Bath Clean Air Plan

Bath and North East Somerset Council

Clean Air Zone Boundary Updates

674726.BR.042.FBC-04 | 2

Figure 2-10: Boundary Changes Under Consideration

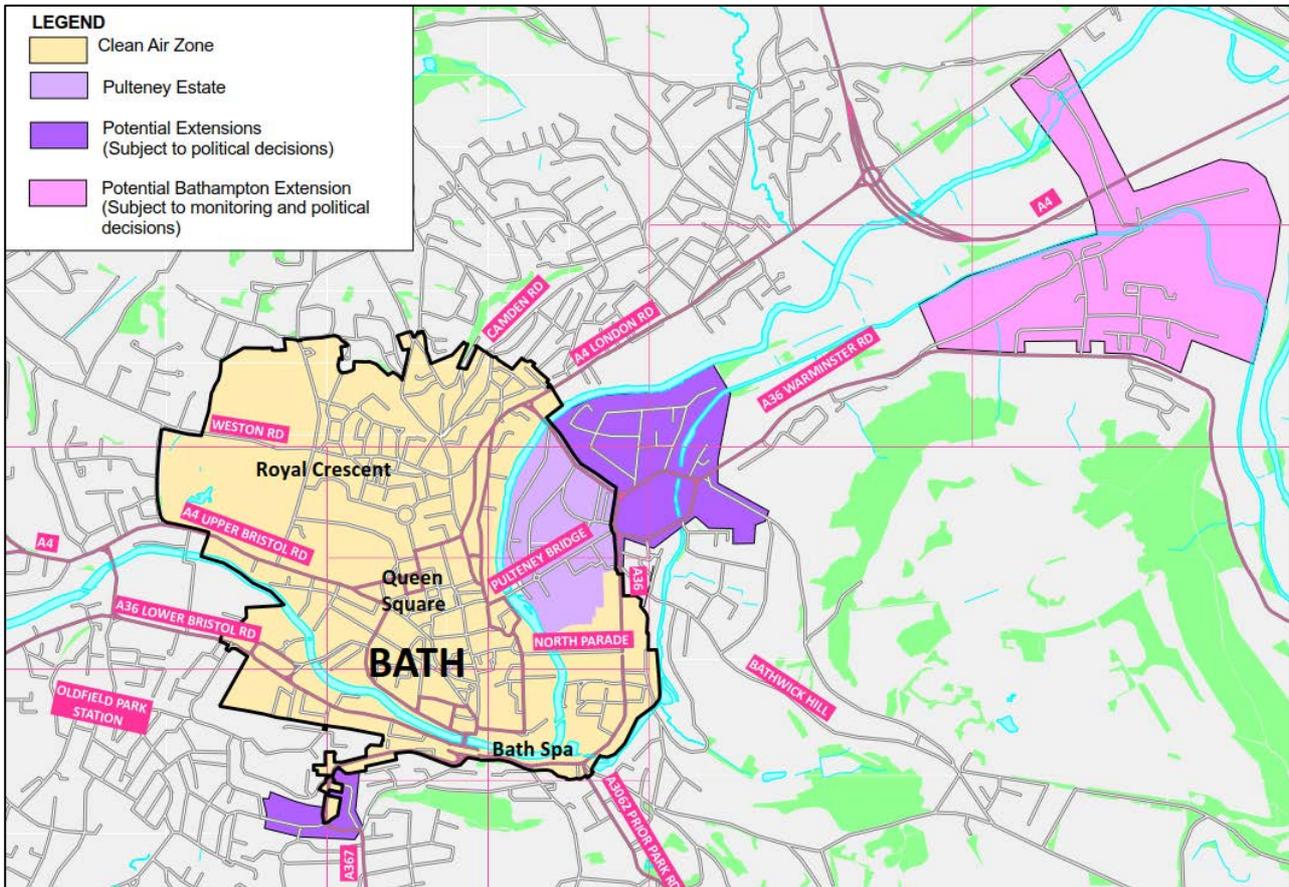
A further three proposed extensions to the CAZ boundary were presented for political decision at the final OBC sign-off and are shown in **Figure 2-10** above, highlighted in purple and pink.

The purple areas were selected for inclusion and comprise:

- To the south of the zone, further inclusion of the A367 Wells Road up to, but not including, the junction with Holloway, so including the length of the B3111 Oldfield Road up to, but not including, its junction with Junction Road.

- During the consultation period, contrasting feedback was received about moving the CAZ boundary to cover the A367 Wells Road/B3111 Oldfield Road junction. This was as follows:

- There were concerns about additional rat-running, parking, congestion and decreased air quality along both Oldfield Road and in Oldfield Park generally if the junction were to remain outside the zone and the B3111 open (Noting that the northern end of the B3111 is covered by the inclusion of the A36/B3111 Brougham Hayes junction within the present CAZ boundary already).

- 2) Inclusion of the wider Bathwick area to the east of the zone, including A36 Beckford Road, A36 Warminster Road (past the junction with North Road), North Road (to the junction with Cleveland Walk), Sydney Road and Sydney Place.

- During the consultation period there were concerns from residents in the Pulteney and Bathwick Estate about an increase in idling coaches, rat-running traffic and drop-offs or parking of non-compliant vehicles in the area, as it was very close to the city centre.

- Pulteney Estate Residents Association (PERA) and Bathwick Estate Residents Association and several individual Bath residents requested that such an area, as shown by the purple, should be within the CAZ boundary.

- As shown in Section 2.7 point 1), a smaller extension covering the Pulteney Estate has now been included. This does not interfere with Sydney Gardens or Bathwick Roundabout, maintaining a suitable turning point for non-complaint HGVs reaching this part of Bath on the A36(T). However, an extension to the zone as shown could have implications in providing suitable opportunity for 'turn-back' or re-routing of non-compliant vehicles, particularly HGVs, entering Bath on the A36(T). Non-compliant vehicles would be forced to turn around using residential estate roads prior to a repositioned zone entry point on the A36 just east of the North Road junction to avoid entering the CAZ. This is potentially unsuitable for HGVs and could lead to 'entrapment' issues with non-compliant large vehicles proceeding northbound on the A36(T) beyond the B3108 Little Stoke junction to the south of Bath (Winsley).

The pink area to the east of the zone is a potential 'outlier' zone covering Bathampton. It's inclusion will be subject to traffic and air quality monitoring and should issues arise, a political decision. It is therefore not included at this time. This zone extension sitting between the A36 and London Road West would include: Bathampton Lane, Down Lane Devonshire Road, High Street, Mill Lane and all side roads with access off the roads listed. At the present time this extension is on balance not considered necessary after weighing up the following:

- Bathampton Parish Council, Batheaston Parish Council and Bathampton Primary School all requested an extension of the CAZ zone to cover Bathampton.
- During the consultation period the organisations above and many respondents expressed concern that the current boundary would lead to large amounts of traffic diverting through Bathampton and across the toll bridge. As a result, this would cause issues with increased congestion and worse air quality in Bathampton. They also highlighted a potential safety issue with additional parked cars, and a greater risk to pedestrians, especially children, in Bathampton from increased traffic.

- However, modelling has predicted that the traffic is not expected to increase excessively across the toll bridge, the route is already heavily constrained by the capacity available in peak hours and this is well known by local drivers.

- Further to this there is no case to include this area to achieve air quality compliance by 2021.
- There are also concerns that including this area would leave no convenient crossing point over the River Avon to the east side of the city for non-compliant drivers, with the B3108 at Winsley offering the nearest viable alternative, well to the south of Bath.

As such it was proposed to introduce a programme of regular monitoring to establish changing traffic flows and potentially journey times on the Bathampton Lane/Mill Lane/Toll Bridge Road route in the pre-CAZ and post-CAZ scenarios. Comparison of 2014 and 2018 flows on Toll Bridge Road has shown no appreciable change in two-way 'peak' weekday flows at the Toll Bridge, but a perceivable growth change in the average inter-peak hour flow over the period 2014-2018. Further data collection up to CAZ implementation will enable what appears to be an underlying growth trend to be established. In the post-CAZ scenario, this can then be accounted for in establishing any true 'extra-over' effects of the CAZ. If the outcome from future comparison

analyses does reveal a net impact of significance, then a decision could be taken then to introduce an 'outlier' CAZ if required, subject to a full public consultation. As the route is already subject to a 4-ton weight restriction and has traffic calming and a 20mph speed restriction in parts, it is considered that little could be achieved using further formal traffic management measures to deter vehicle usage. Increasing charges on the Toll Bridge is also outside of the control of B&NES.

Figure 2-11: Eighth Proposed Amendments to the CAZ

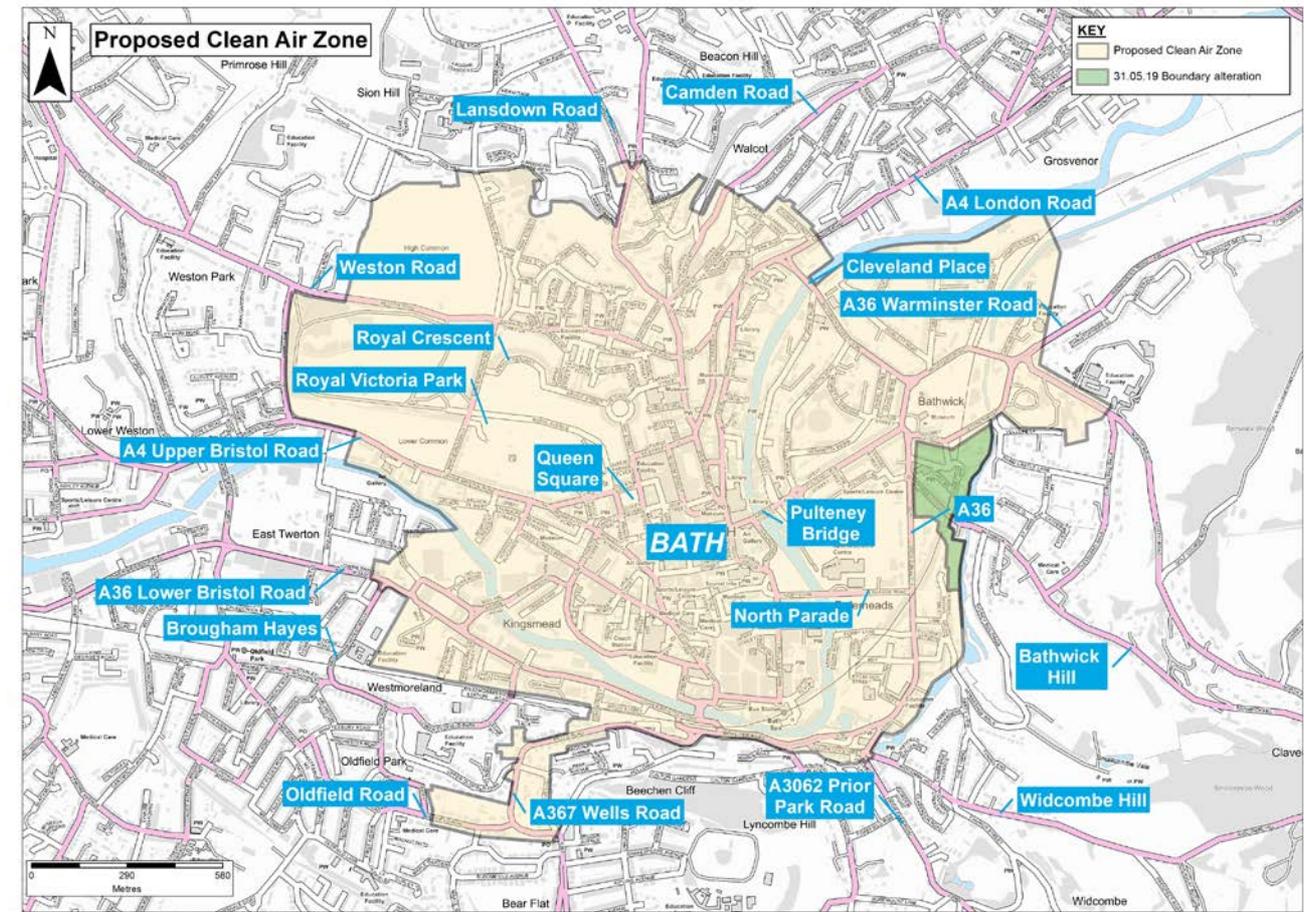
A further minor change is proposed to the boundary for practical reasons. The area adjusted is highlighted by the green shading in **Figure 2-11**. The boundary as it stood before would require four camera locations, at; Sydney Mews, Raby Mews, Sydney Wharf and Sham Castle Lane. This would require 7 ANPR cameras and 16 signs to monitor a very predominantly residential area.

As is shown, extending the boundary to the canal from Sydney Road to Bathwick Hill will define the zone more clearly and reduce the infrastructure requirements to 3 ANPR cameras and 8 signs. Further advantages of revising the boundary are:

- It makes technical installation easier to achieve (power/communications/installing posts);
- Reduces negative impact on streetscape;
- Aligns to include all of the associated Residents Parking Zone;
- Doesn't discriminate between different areas of Bathwick i.e. some properties in and some out of zone; and
- Leaves potential to redeploy cameras elsewhere or reduce/reallocate budget.
